Campaign No. 2021060014, July 2021
Revision A July 2021

SUBJECT: **Model G-Class vehicles (463 platform)**
Model year 2019-2020

Replace Rear Door Lock – Code XZ8/XZ9 (MY19/MY20)

Figure 2

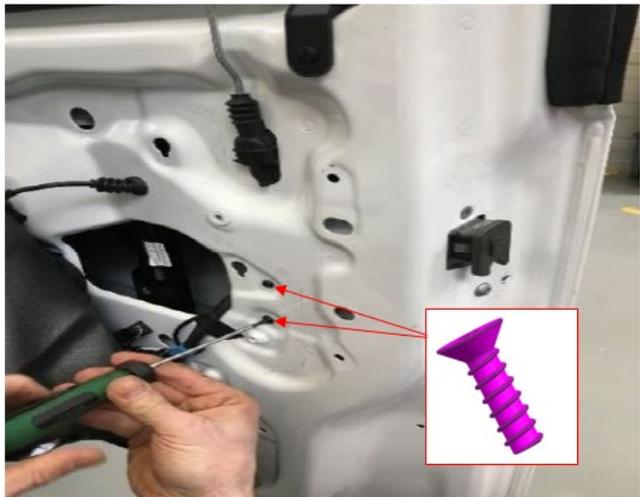
4. Complete unit consisting of door lock, actuator motor of central locking system with release cable, and door locking knob prior to installation and insert into door to assemble.

i The mounting screws on **CL actuators (Figure 3) MUST be replaced** and are included with the parts kit.
